Title - Sujet Growth Chamber Replacement	
Solicitation No. - N° de l'invitation EZ899-160989/A	Amendment No. - N° modif. 003
Client Reference No. - N° de référence du client	Date 2015-09-24
GETS Reference No. - N° de référence de SEAG PW-\$PWY-028-7611	
File No. - N° de dossier PWY-5-38175 (028)	CCC No./N° CCC - FMS No./N° VME
Solicitation Closes - L'invitation prend fin at - à 02:00 PM on - le 2015-10-01	
F.O.B. - F.A.B. Plant-Usine: <input type="checkbox"/> Destination: <input checked="" type="checkbox"/> Other-Autre: <input type="checkbox"/>	
Address Enquiries to: - Adresser toutes questions à: Lam (PWY), Tian	Buyer Id - Id de l'acheteur pwy028
Telephone No. - N° de téléphone (604) 775-9382 ()	FAX No. - N° de FAX (604) 775-6633
Destination - of Goods, Services, and Construction: Destination - des biens, services et construction: AAFC - Pacific Agri-Food Research Centre - Summerland, BC

This Amendment 003 is raised to include:

**The following changes/clarifications in the tender documents are effective immediately.
This addendum will form part of the contract documents.**

MECHANICAL ADDENDUM # 1

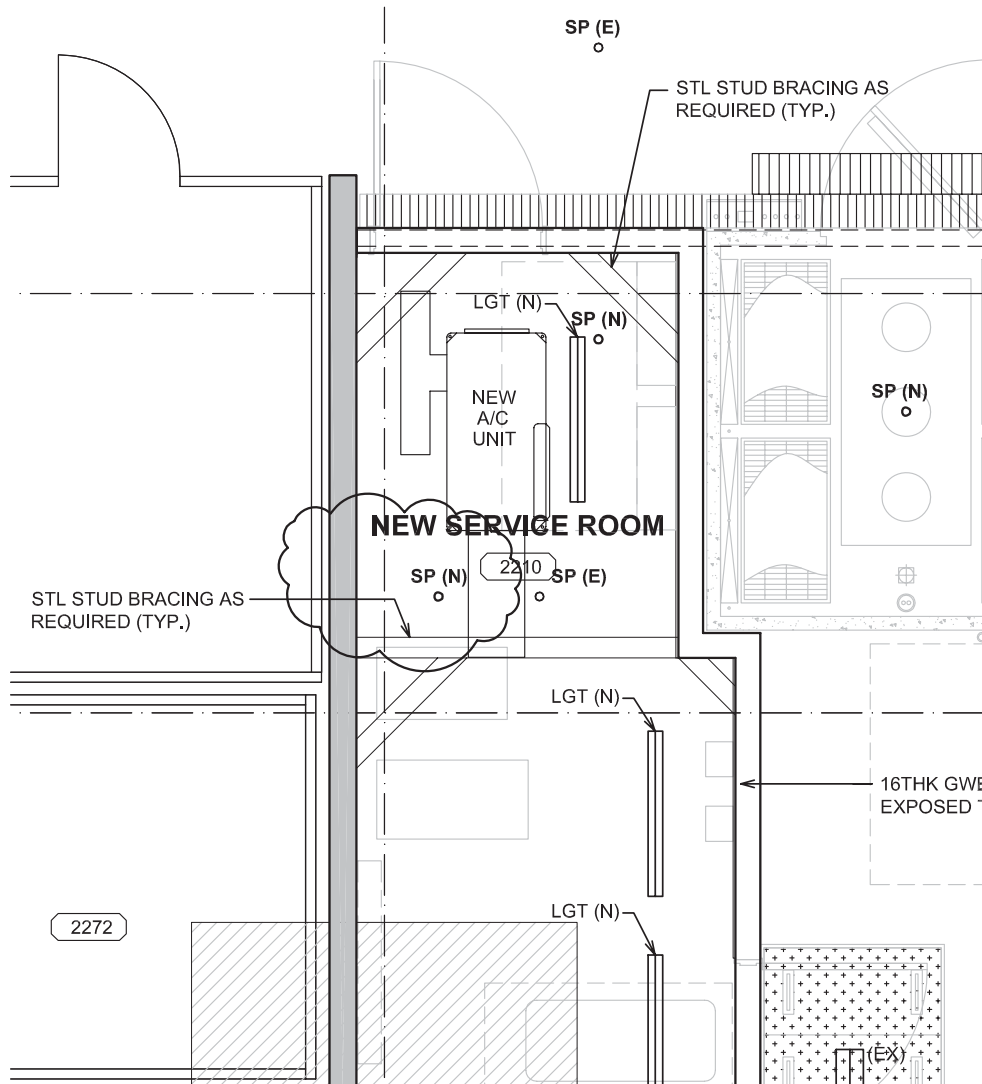
2.1 Refer to attached drawing AD-01 1/05 Reflected Ceiling Plan New Work for minor clarification of sprinkler.

-
11. Some of the Fire Sprinklers shown on drawing A-05 (GL19) are not included on drawing F-200, are we to include these sprinklers?
Response: Those shown on A-05 are for future chambers. Provide new tees with capped off piping stub for the future sprinkler heads for the Growth Chambers (1 on G.L. 18 and 3 on G.L. 19). Also refer to attached AD-01 for minor clarification.
